Field Observation Report No. 14

Date: 5/19/10 - Tile Punch List

Project: Bharatiya Temple

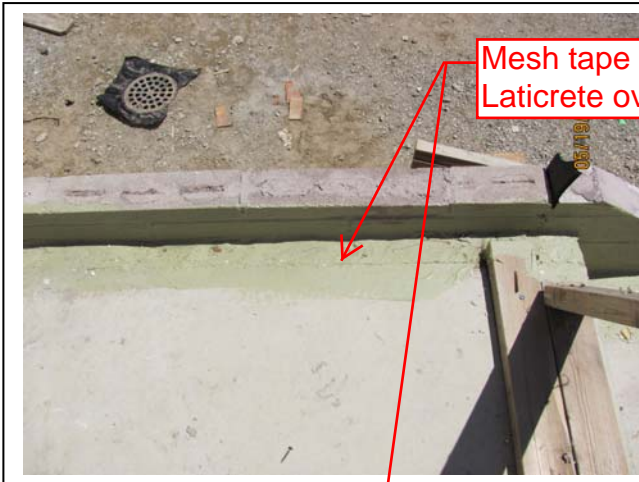
Tile color to match sill.
Remove and replace
jamb & head.

Additional coat of
Laticrete needed.

Mesh tape embedded in
Laticrete over all joints

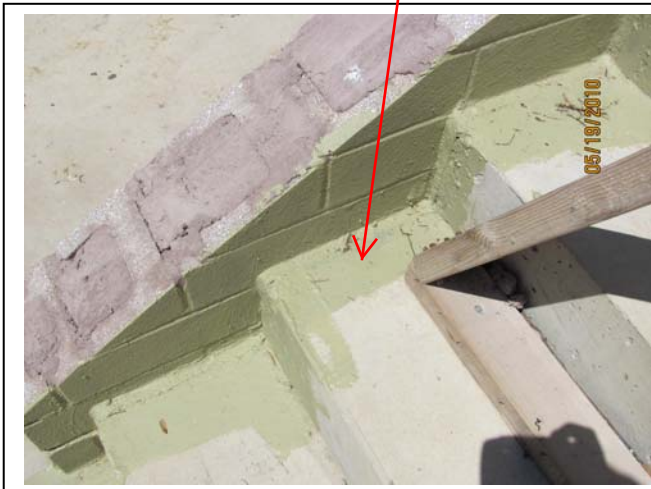
Extend Laticrete &
mesh to end of
landing.
